ISSUED ON: October 15, '93 Serial Date of Model Volt/Hz N865 (VT2105, Ges5325, Rex1250, NSA CP325) Modification Number **Modified Article Reverse Roller Clutch** Reason for To erase horizontal white line in photo mode Modification Parts Inter-Part needed for replacement by new part **Old Parts** New Parts Q'ty Used Draw Catalog Description Rank change- $Old \rightarrow New$ No. No. No. ability Part No. Description Page No. C2168122 C2168123 Main Control Board - 230V 0/0 $1 \rightarrow 1$ 31 67 Main Control Board - 115V 0/0 C2168112 C2168113 $1 \rightarrow 1$ 31 67 C2158045 C2158057 IC - Main Board $1 \rightarrow 1$ 0/0 32 67

Model	N865 (VT21	05, Ges5325, Rex1250, NSA C	P325)				Volt	/Hz	Date of Modification		erial nber
Мс	odified Article	Main Board,	Image Processing Board									
	Reason for Gestetner version: To enable computer link up Modification Inter- Part pool											
Draw No.	Old Parts No.	New Parts No. Description		Rank	Q'ty Used Old $ ightarrow$ New	Inter- change- ability	change-		ed for replacement by new part Description			arts alog Page
	00450000	00070000										
	C2158088	C2078088	Flat Cable - Main Board		$1 \rightarrow 1$	X/X		/O as a set (/O, if the comput nk

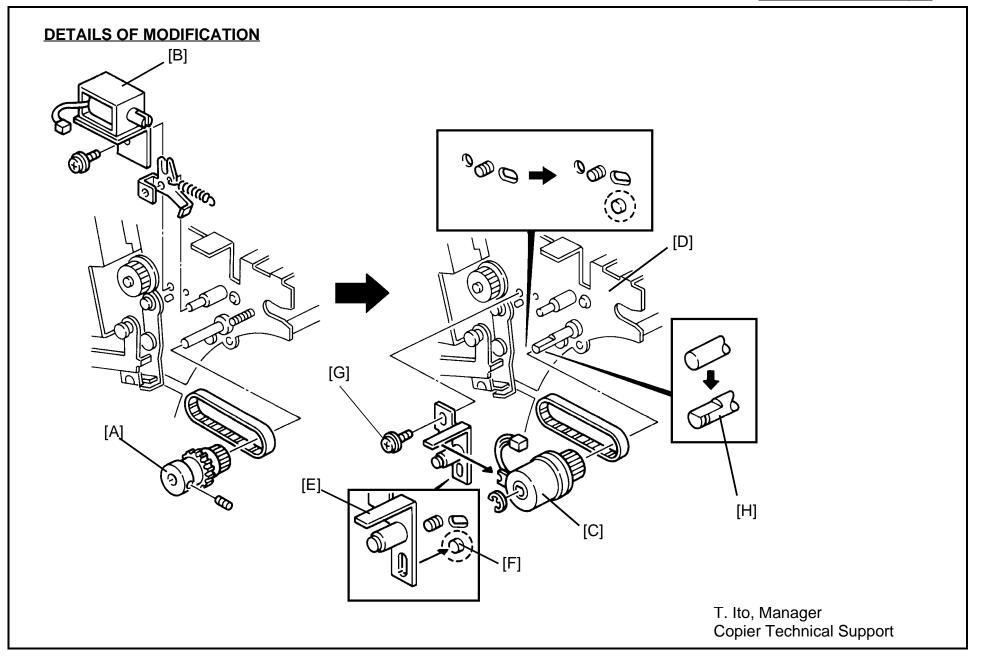
1. To erase this white line, the software has been changed to delay the timing of the master clamping. With the old software, the reverse roller solenoid [A] and the master clamper solenoid were turned off at the same time. (Due to the slow response of the old spring clutch, the reverse roller stops feeding the master after the master was clamped.) The new software enables that the master is clamped when the master is fed 2 mm further after the reverse roller stops feeding the master. This allows to make a small buckle of the master, which absorbs the shock wave, between the platen roller and the reverse roller before the leading edge of the master is clamped.

2. To enable the proper reverse roller stop timing, the reverse roller clutch mechanism has been changed from the conbination of a solenoid [A] and a spring clutch [B] to an electrical clutch [C]. To cope with the strictly controlled reverse roller stop timing, the electrical clutch responds a little bit quicker than the old clutch mechanism. (If the old spring clutch is used, the only side effect is as mentioned above.)

To make assembly of the clutch stopper [E] in the factory easier, a projection [F] is added on the right side plate [D] (C2164005). Even if the side plate does not have this projection, the clutch stopper can be installed on the side plate with one screw [G] (09604008Z). So, the part number of the right side plate has not been changed. Also, the shape of the upper reverse roller shaft [H] has been changed to match the electrical clutch. The old spring clutch [B] can be replaced with the new electrical clutch [C] (C2158240) with the clutch stopper [G] (C2154200) and the upper reverse roller (C2154046).

The new ROM can be used also for existing machines. The only side effect is that the image on prints is forwarded about 1 or 2 mm due to the slow response of the old mechanism. (This value varies due to ratchets of the clutch gear.) If the old ROM is used for a modified machine (this is the same situation as the new clutch mechanism installed on the old machine), the image is shifted approximately 0.6 mm backwards.

5. All versions

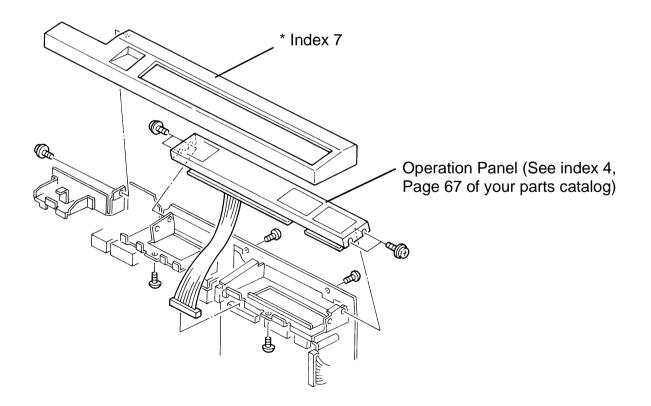
Correct the illustration in the EXTERIOR section as follows:

Page 59 PLOTTER / MASTER FEED SECTION 2

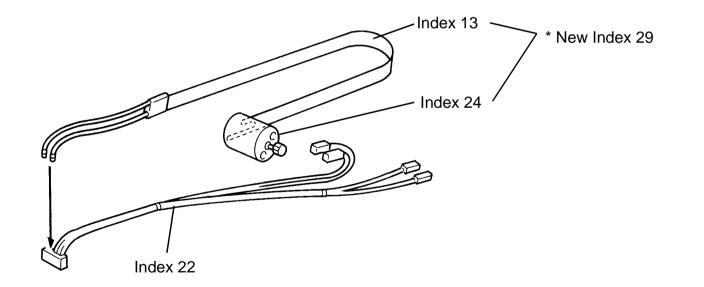
Add the following part and correct the illustration as shown below:

New Index No.	P/N	Description	Q'ty
29	C2008415	Motor / Cable Ass'y	1

* The motor (C2008418) and flat cable (C2008417) are soldered, and they are supplied also as an assembled part as shown below.

Page 61 PLOTTER / MASTER FEED SECTION 3

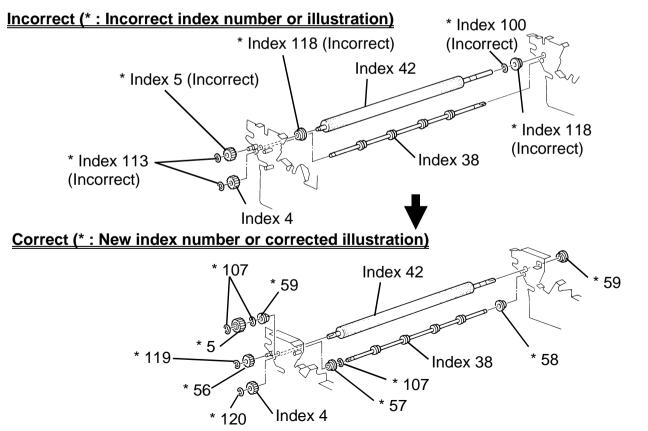
Add the following parts and correct the illustration as shown below:

New Index	P/N	Description	Q'ty
56	C2002338	Gear - 20T	1
57	53241658	Bushing - 4 x 8 x 4.5 mm	1
58	H0022226	Bushing - Head Roller	1
59	H0121181	Bushing - M6	2
119	07200020Z	Retaining Ring - M2	1
120	07200025Z	Retaining Ring - M2.5	1
